Project: 23-061 DRIVEWAY CHANGE ORDER
Description: PRIMROSE CANAL DRIVEWAY AT
339 ST JOHN STREET

Revised Plan Set Drawings

PRIMROSE CANAL CLEANING AND IMPROVEMENTS

ELLINGTON CANAL
(PRIMROSE CANAL)
PLAN AND PROFILE
PHASE 1A

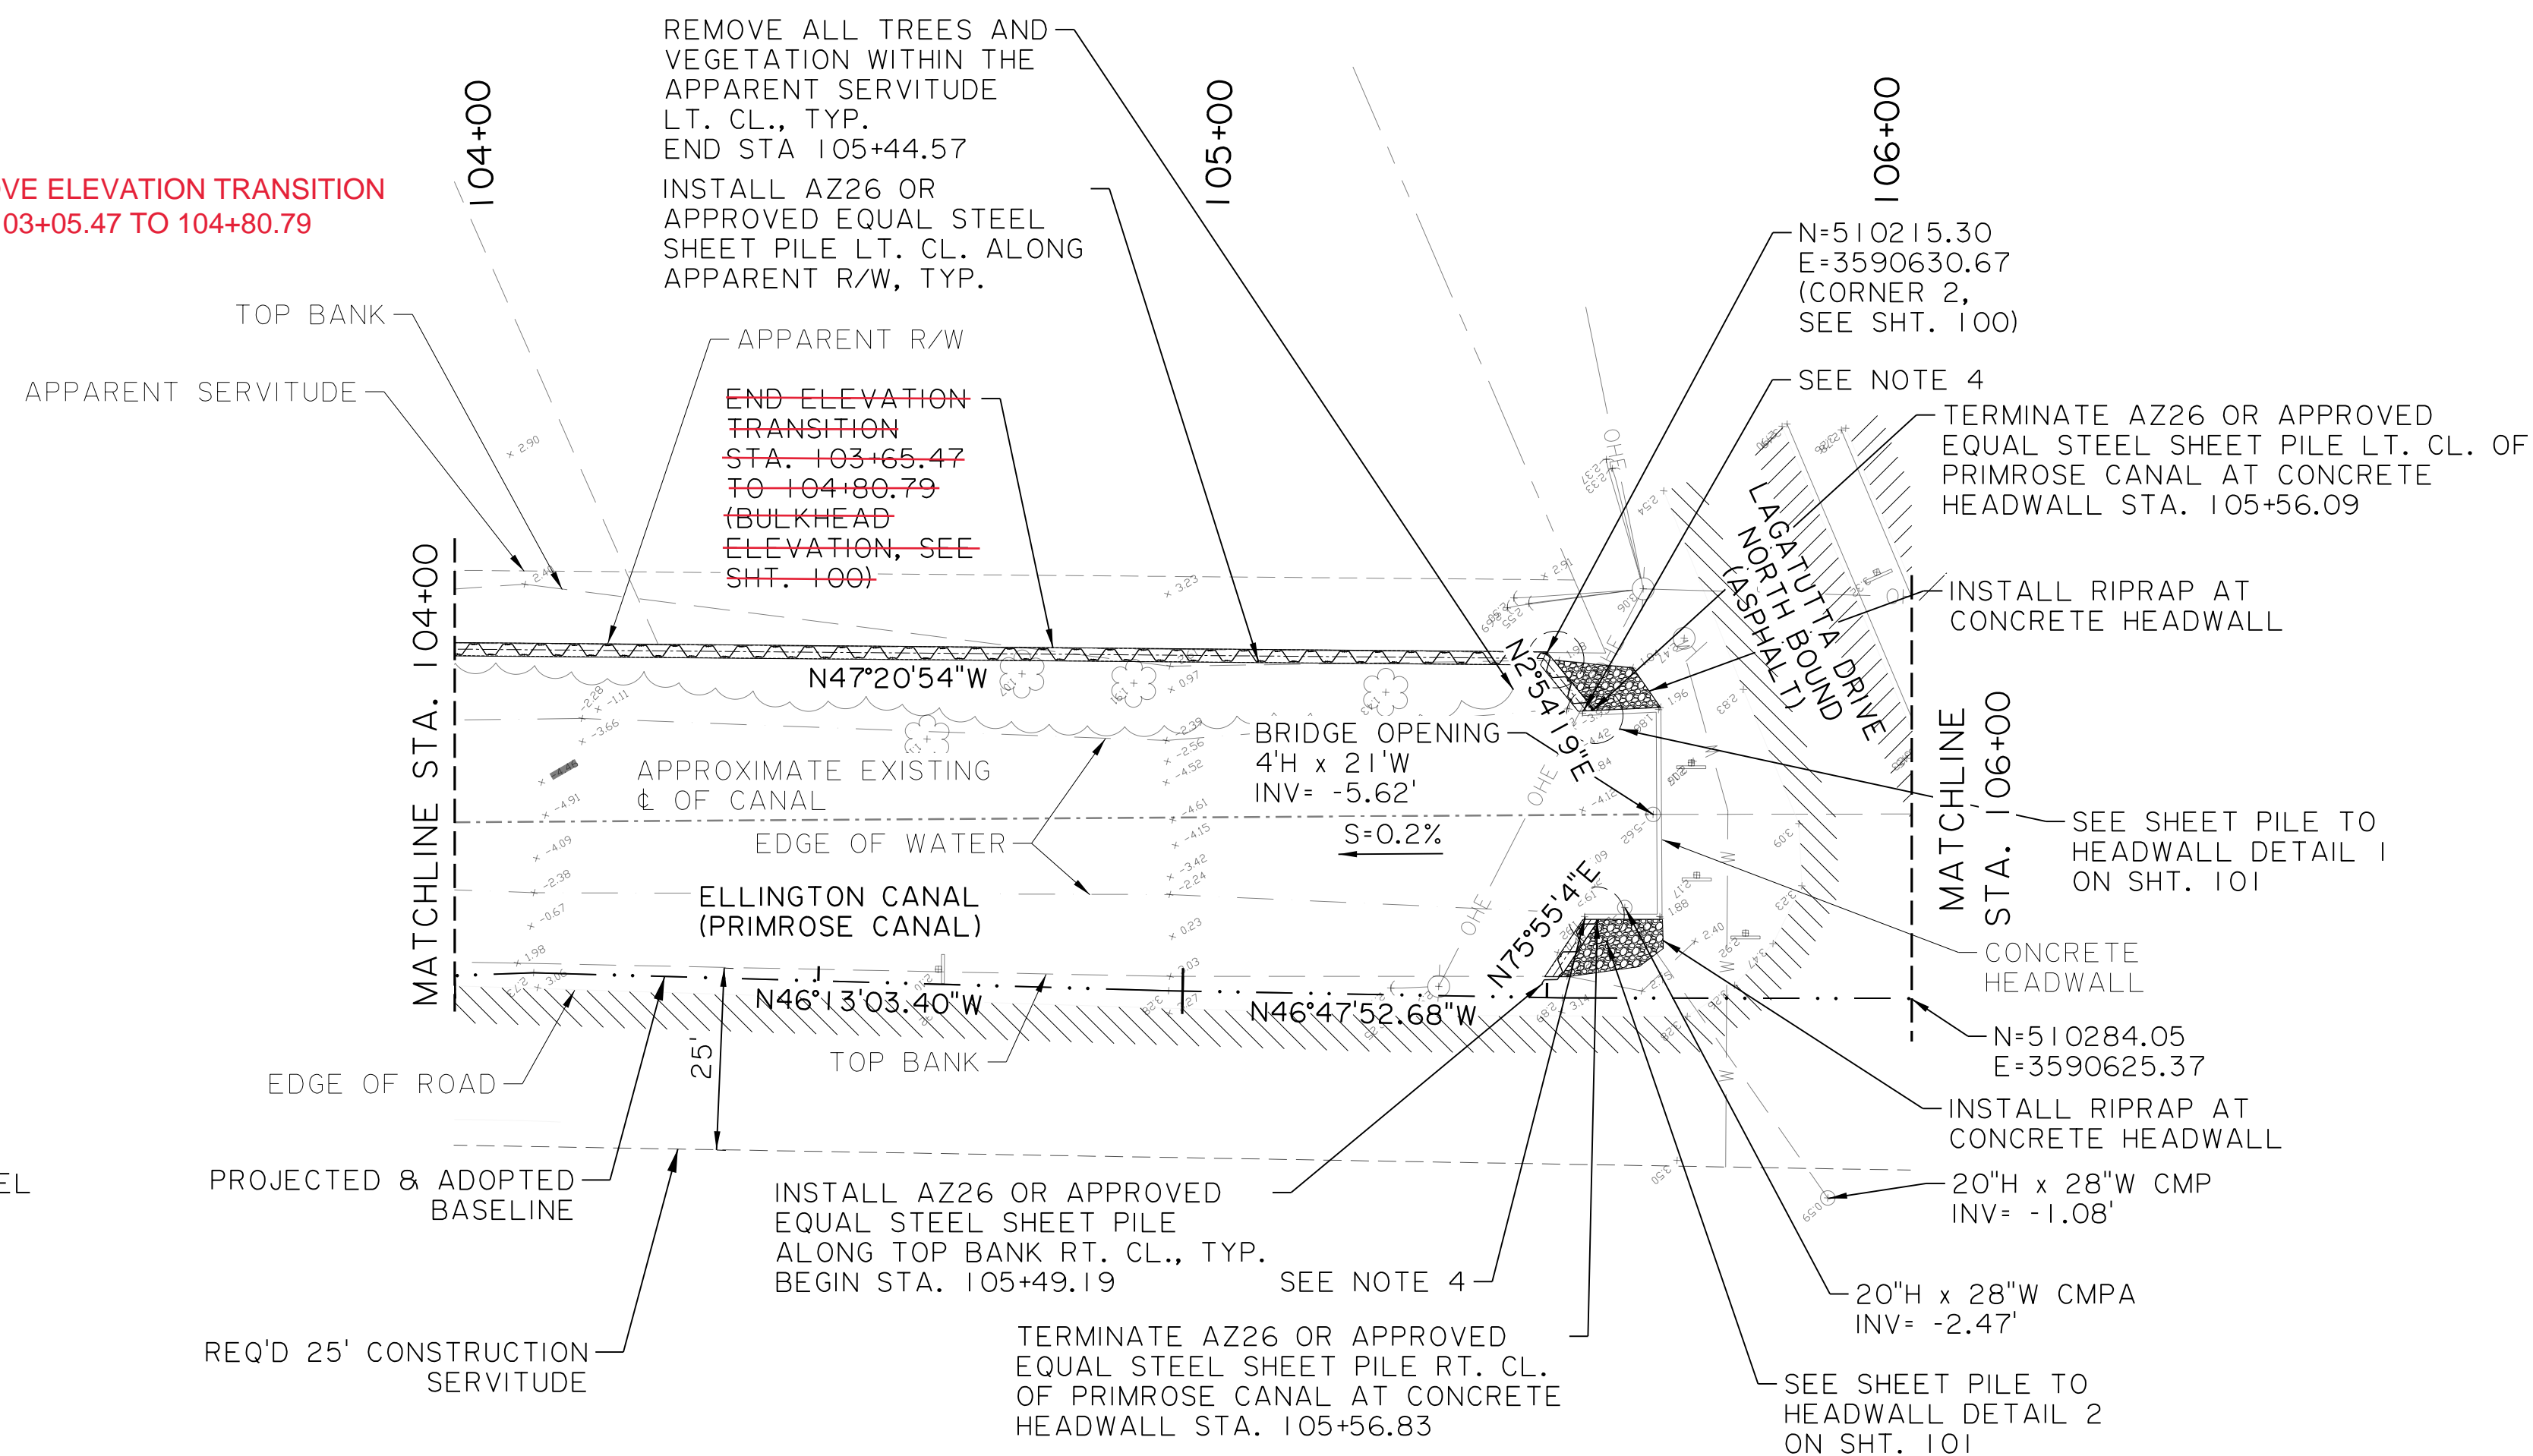
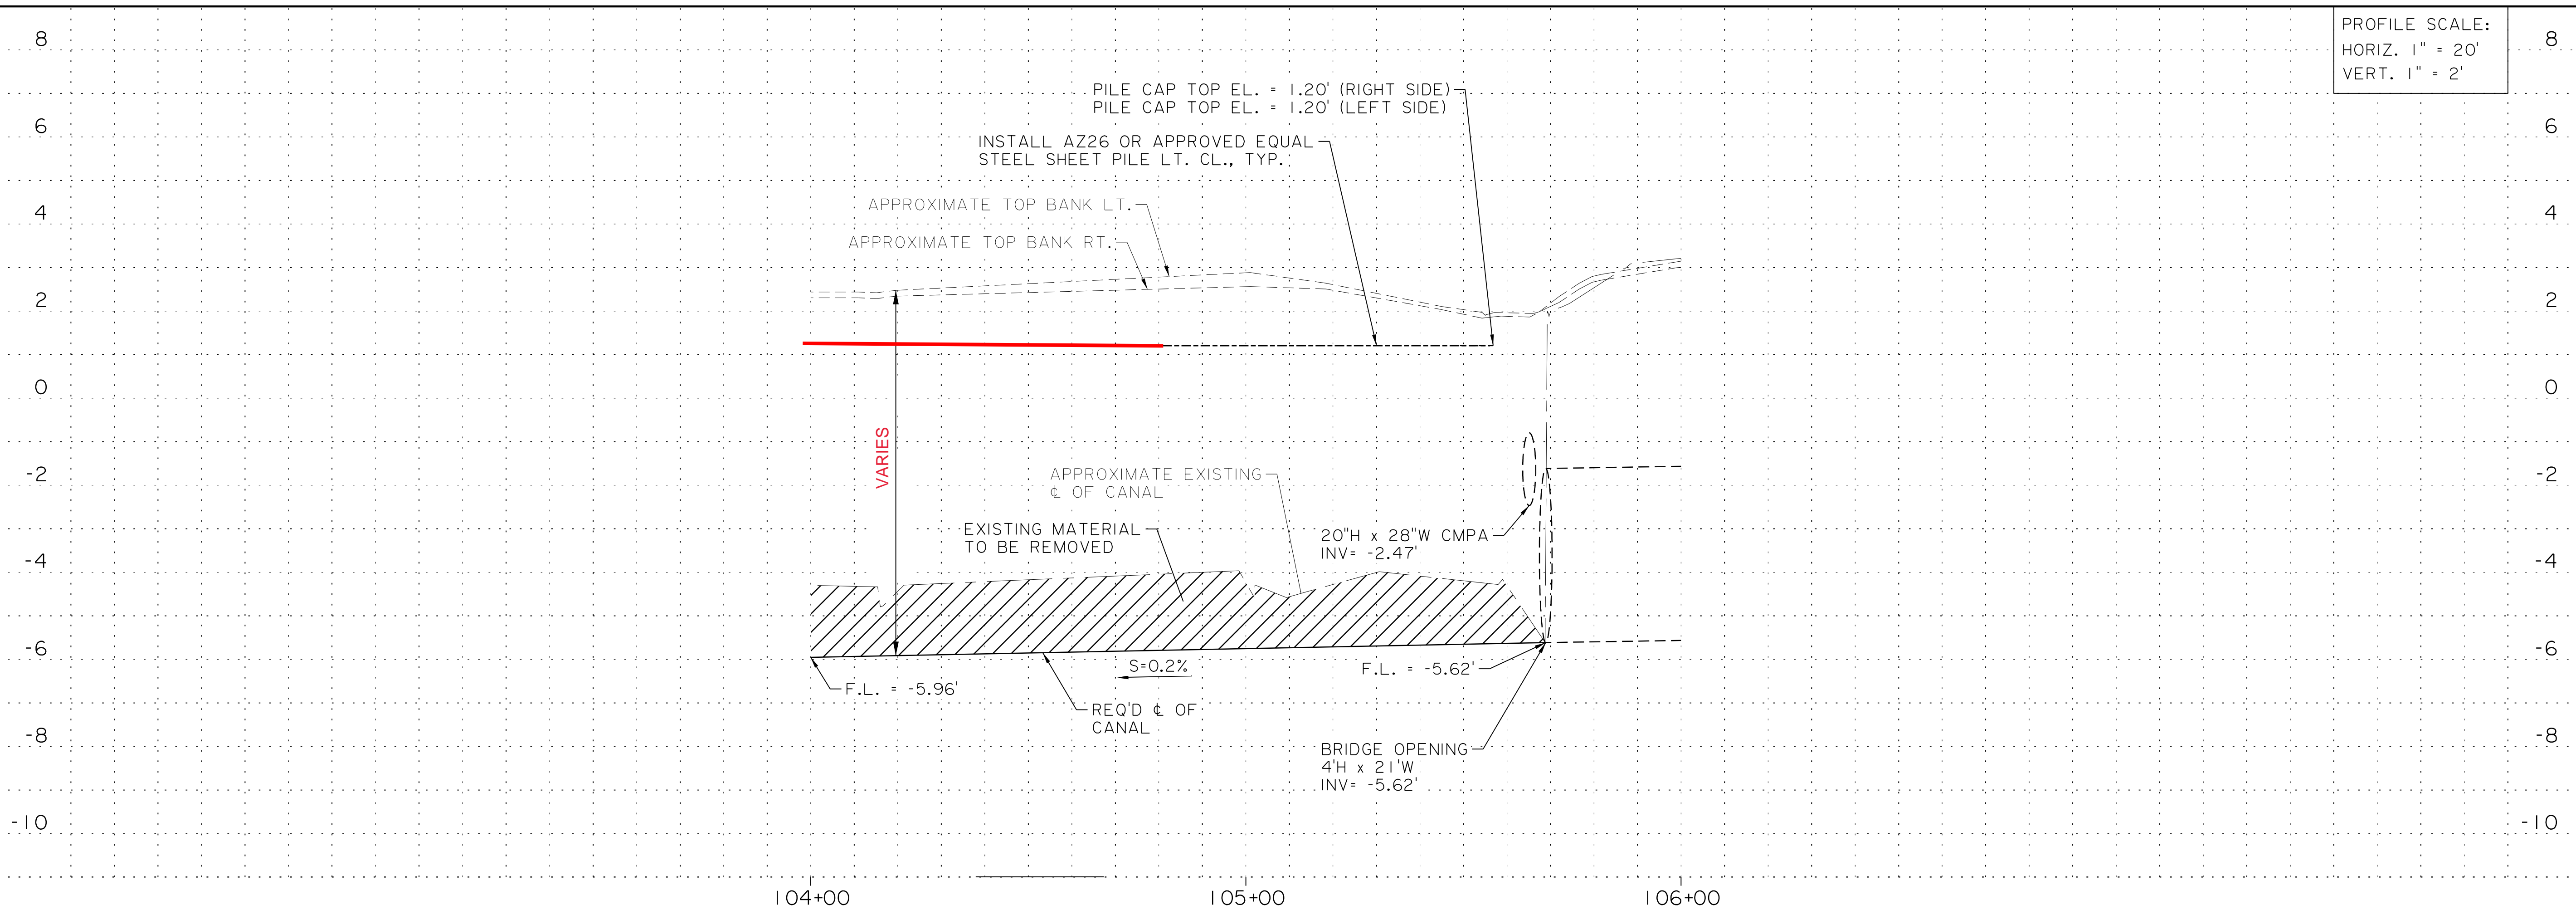
REMOVE ELEVATION TRANSITION
STA. 103+05.47 TO 104+80.79

END ELEVATION
TRANSITION
STA. 103+65.47
TO 104+80.79
(BULKHEAD
ELEVATION, SEE
SHT. 100)

ALL RED LINES SHOWN ARE TO
BE INCORPORATED AS FIELD
CHANGES.
DATE: 5/17/24
ENGINEER: DUSTIN GUIDRY
